Inspection and Replacement of Carb Bracket

SD-1007

Evolution Trikes

Oct 04, 2011

Fig-1

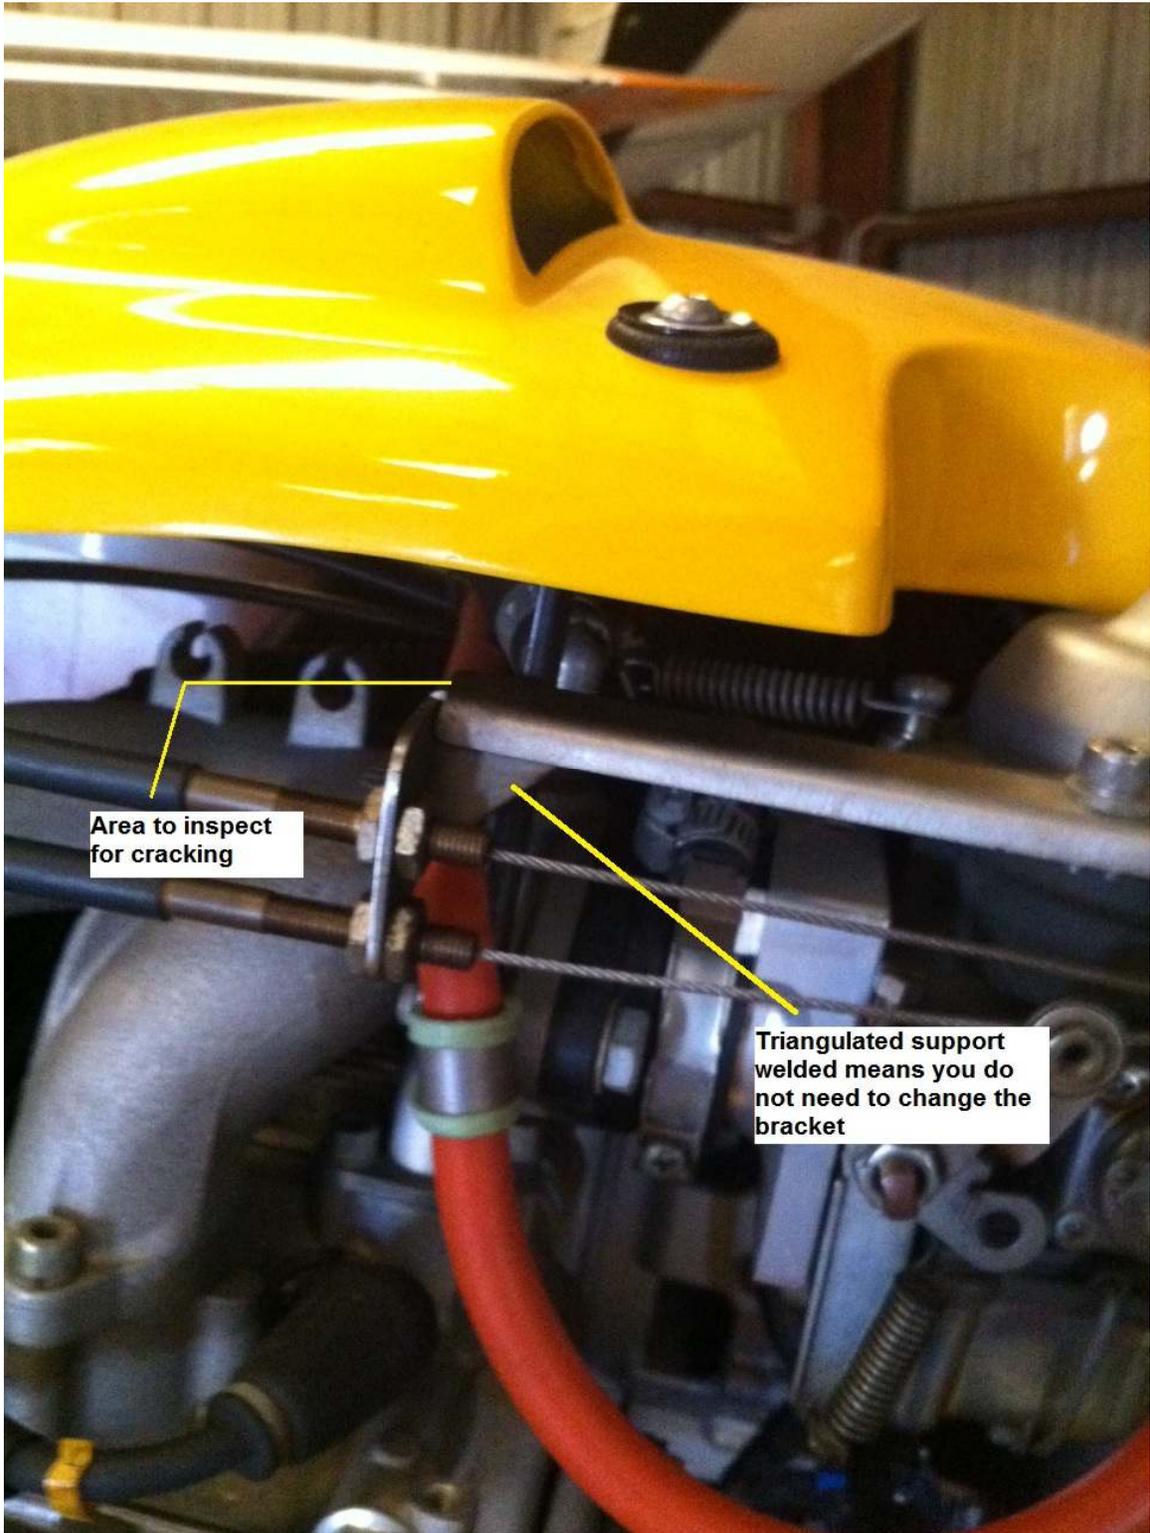
There has been one incidence in the field of a carb bracket on the Revo (Rotax 912 series engine) cracking at 70 hours. Although this doesn't suggest a trend and the bracket on the other side on the same machine didn't experience any cracking; we have decided that in the interest of safety, its best to inspect and replace this bracket for a certain serial number range. On aircraft 000550 through 000562, the brackets used a sharper bend that may cause stress that can be reduced with a larger radius bend in newer brackets and a welded triangular or straight support.

- 1) If the serial number of the aircraft is between 000551 through 000562, 007, also between 1001 through 1004 –and- if these brackets do not have the triangulated support welded to them as shown in Fig. 1, these brackets will need to be changed with new brackets provided by the manufacturer at the next 100 hour inspection or before by a mechanic. The guidance for changing the brackets is as follows

- a) Remove engine cover if applicable
 - b) Using allen head sockets loosen cable retaining stops in the throttle and choke cable so the cable can be pulled out

- c) Using 7/16” open end sockets, the ¼ x 28 cable housing retainer fitting can be taken off the bracket face. At this point the bracket should only be held in place by the two fasteners securing it to the carbs itself

- d) Remove the bracket
 - e) Reverse to install the new bracket. Secure cables and cable housing retainers roughly in the same place as before
 - f) Check your work and tug on cables to make sure everything is secured
